SAFETY INFORMATION PCI 63000224

Subject: Instruction PCI N°63000224 sent by TKEMS

PRODUCT CORRECTION INSTRUCTION
OVERSPEED GOVERNOR SG-200 & SG-300 ELECTRIC CONTROL FAULTY

No.: PCI 63000224 Rev. 01
 Page: 1
 DATE Rev. 00: 21/07/2014
 DATE Rev. 01:17/09/2014

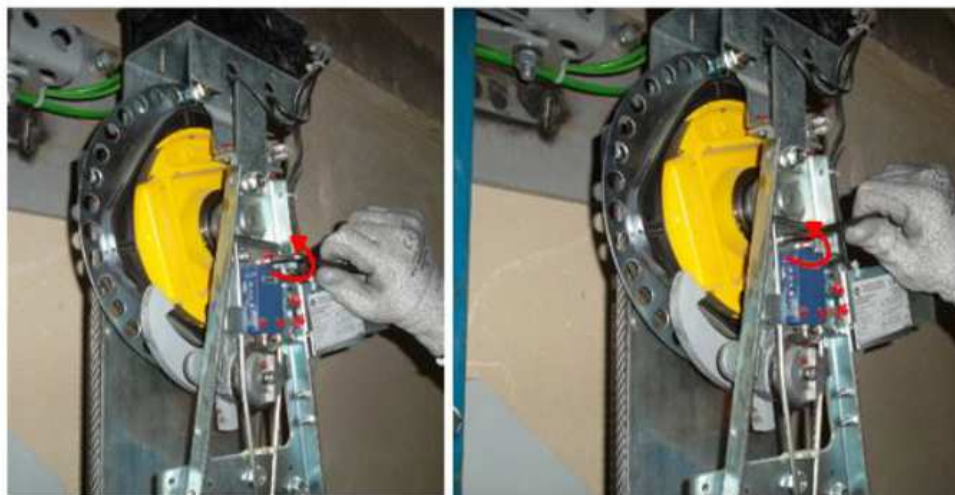
2.2.1.1. Loosen half turn the screw of the cam actuator indicated in the picture

2.2.1.2. Push the cam actuator to its top position.

2.2.1.3. Tighten the screw of the cam actuator

On MC3 controller for the Synergy NC91A :

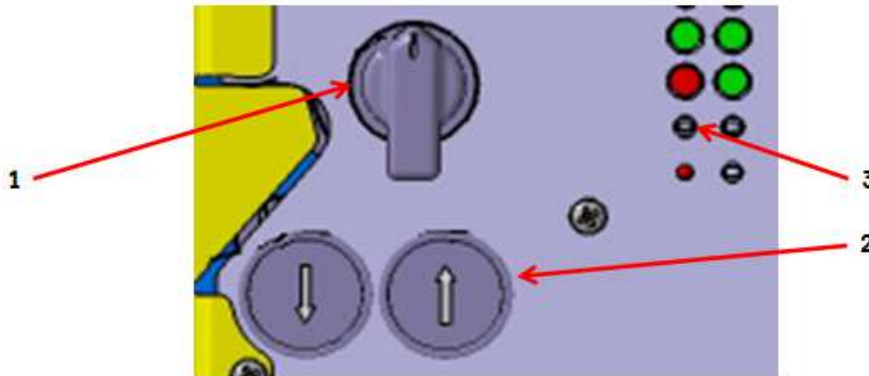
- Put the switch « Normal/Recall » on to Recall (S01 on 1, see ref **1**),
- See the electrical wiring diagram of the lift file,
- Switch off the circuit breaker F02 (check absence of voltage between terminals X2.N and X1.115 with a Voltage Detector),
- Disconnect the 2 wires, of the over speed governor contact cable, from terminals X1.115 and X1.120 located at the bottom of the service box (reconnect the 2 wires on a connection terminal strip),
- Put the circuit breaker F02 back to normal,
- Put a continuity tester on the 2 above wires previously disconnected (use the connection terminal strip),

- Make a call in the upwards direction (press the S01F button , see ref **2**),
- During the run, engage the safety gear (press the safety gear button S25, see ref **3**).

If the tester sounds, please refer to chapter 2.2 ADJUSTMENT OF THE OVER SPEED GOVERNOR CONTACT (see instruction PCI 63000224).
If the governor contact is located on wall side with no access for adjustment, please dismantle it according to the maintenance manual 3017422.

On MHC/ECOR controller for the Synergy NC91B :

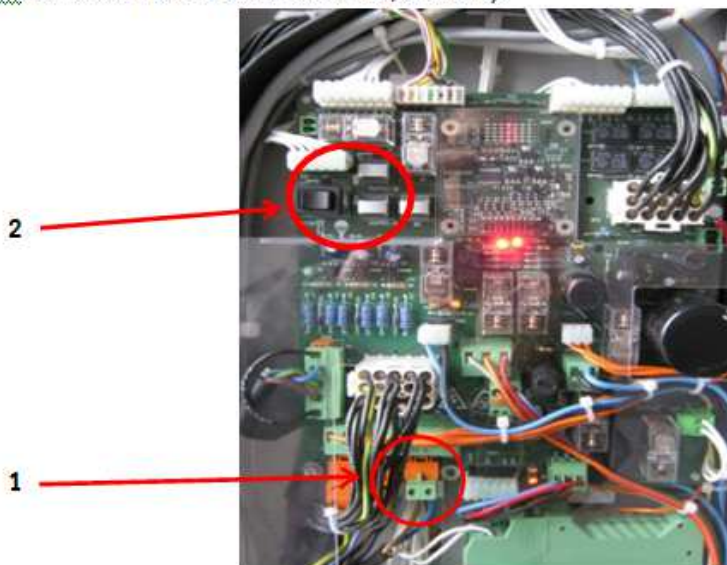
- Make a call in the upwards direction (press the S01F button↑, see ref **2**),
- During the run, engage the safety gear (using the MHC screen, go to the menu « 4. Diagnosis », « 2.TUEV tests », « 13.safety gear test », Type of governor : governor 1 (car) or governor 2 (counterweight), Mode: select « Manually », press « OK » to engage the safety gear).

If the tester sounds, please refer to chapter 2.2 ADJUSTMENT OF THE OVER SPEED GOVERNOR CONTACT (see instruction PCI 63000224).
If the governor contact is located on wall side with no access for adjustment, please dismantle it according to the maintenance manual 3017422.
